MAPLE & POPLAR TREE PROTECTION MS

MAPLE & POPLAR DEVELOPMENT

Tree Root Protection Method Statement

5. Fencing Positions

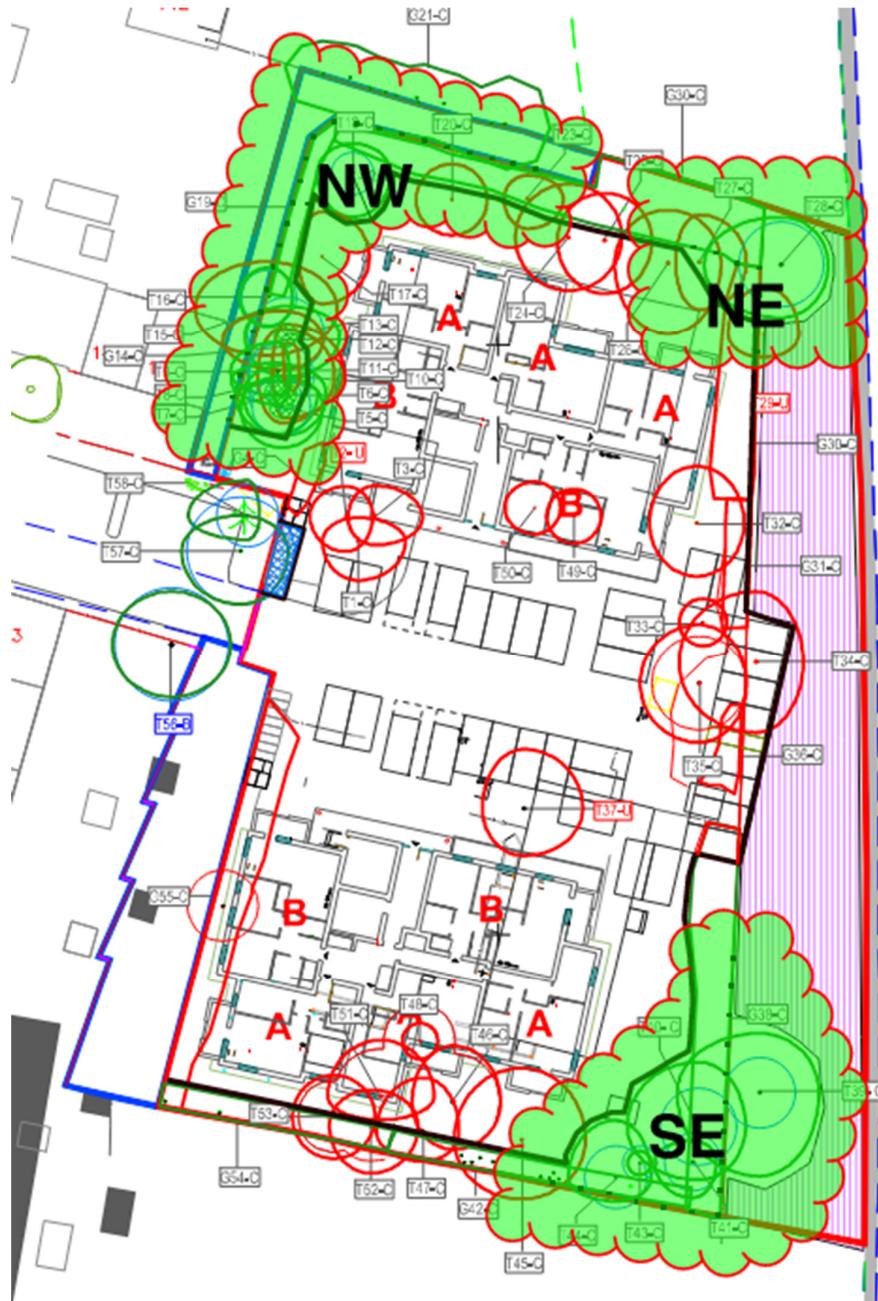
The information provided indicates a 2m high fence edging the public rights of way and 2.5m acoustic fence. The fence goes close to the trunk of an existing tree and within the Root Protection Zones (RPZ) of existing trees. Where fencing is agreed within RPZs, a method statement needs to be provided to ensure these footings will not damage the roots of the trees/hedgerow. The method statement should include:

There are 3 main areas where the new fencing encroaches into the retained tree route protection zones, as highlighted on the site wide drawing below, but then blown up on the following screen shots which show the actual post positions on site.

North West corner

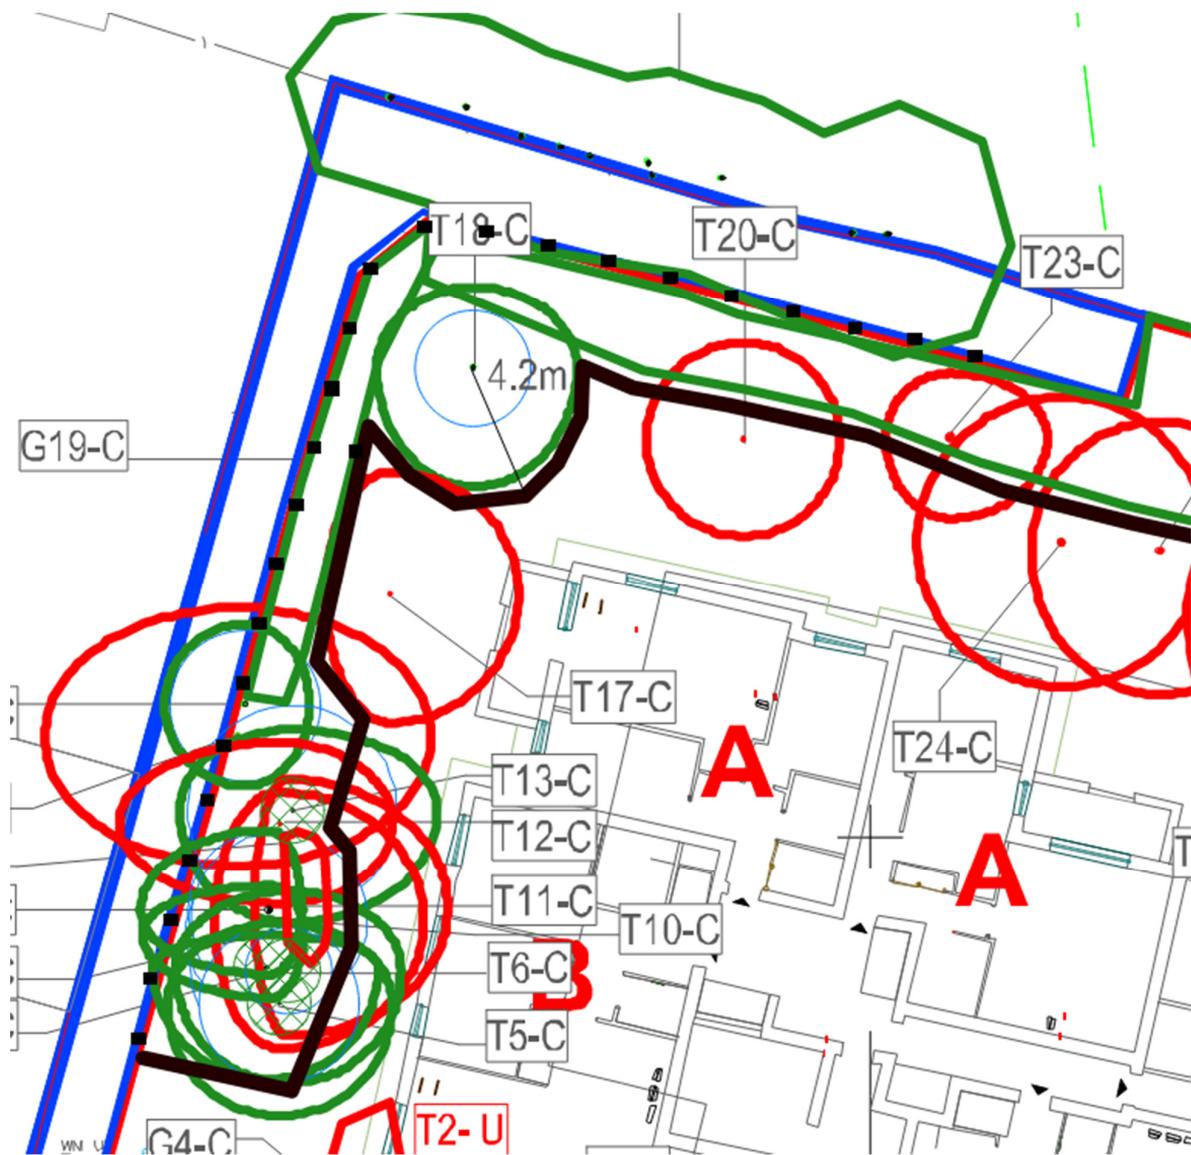
- A plan showing the exact location of the footings;*
- Confirmation all post holes will be excavated by hand and kept as narrow as possible (maximum diameter 300mm).*
- Exploratory post holes will be dug before committing to post / panel positions. If any roots in excess of 25mm are encountered they are to remain intact and the post hole shall be relocated slightly. The fencing system must permit such flexibility, all post holes must be excavated before committing to the final location).*
- Any roots in excess of 10mm which are severed shall be neatly pruned back with secateurs. This will encourage healing and reduce the likelihood of infection.*

This corner consists of 2100mm high close boarded panels at 1900mm post centres. These are indicated by black dots on the below fencing line. There are 2 posts are within the route protection zone of tree T13-C.

All posts holes were dug by hand by our specialist fencing contractor using a post hole digger to keep the holes to a minimum size of approximately 300mm diameter within which the posts were concreted.

I can confirm that during the post installation within the roof protection zones no roots were encountered.
